UNITED STATES PATENT AND TRADEMARK OFFICE

APPLICATION NO.	FILING DATE	FIRST NAMED INVENTOR	ATTORNEY DOCKET NO.	CONFIRMATION NO.
10/612,370	07/03/2003	Kenneth Strannemalm	018798-172	3714

Office Action Summary	Application No. 10/612,370	Applicant(s) STRANNEMALM, KENNETH	
	Examiner Keshia Gibson	Art Unit 3761

DETAILED ACTION***Drawings***

Fig. A: Examiner's markup of Fisher's Fig. 1 to show hip and side sections.

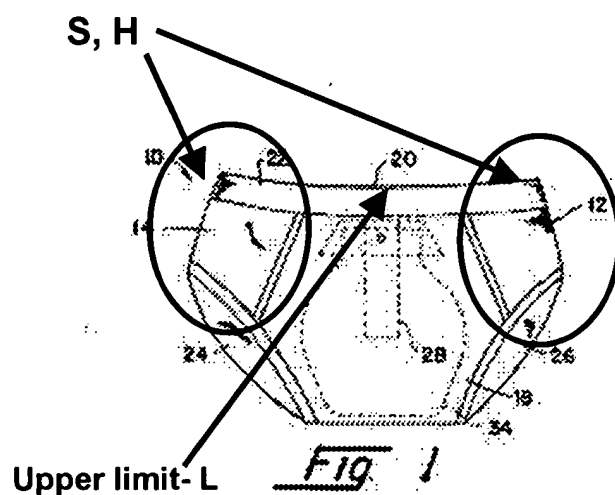
In regard to Claim 1, Fisher discloses a pants-shaped absorbent product 10 for males, comprising a front section 14, a rear section 16, a crotch section 18, side sections S to connect the front section 14 and the rear section 16 in the lateral direction, wherein the side sections S comprise hip sections H, an elastic waist region 12, 22, and an absorbent element 34, which covers the penis of the user (column 2, lines 58-column 3, line 10; Figs 1-2, Fig. A below).

(The front, rear, and crotch sections 14, 16, 18, are disclosed as being elastic (column 2, line 67- column 3, line 1); thus, the examiner considers the brief 12 (and more specifically, its upper half), which comprise each of these regions—along with waistband 22—to be the elastic waist region.) The product further comprises a liquid-tight outer layer 56 to cover the absorbent element 34 (54) at least on the side thereof facing away from the user when the product is worn; wherein the front section 14 has at least one elastic member 22. The elastic member 22 enables the front section 14 of the product to be pulled down during use, counter to the action of the elastic member, to a position in which the upper limit edge L of the front section 14 in the middle region of the front section 14 is situated below the penis of the user, at the same time as at least the hip sections H of the product are arranged to be held in place around the waist of the user (column 4, lines 20-54).

In regard to Claim 4, the elastic waist region 12, 22 completely surrounds the waist; therefore a section of it extends over the front section 14 between the hip sections H (Figs. 1-3 and Fig. A above).

and side sections S (Figs. 1-3 and Fig. A above). The elastic member 22 is shown to have a higher elastic stretchability than the rest 12 of the elastic waist region 12, 22.

In regard to Claim 14, the absorbent element 34 extends in the longitudinal direction over the whole of the crotch section 18 and slightly up over the front section 14 in the direction of the upper limit edge L during use (Figs. 1-3, 6 and Fig. A above; column 2, lines 3-4; column 3, lines 28-34).
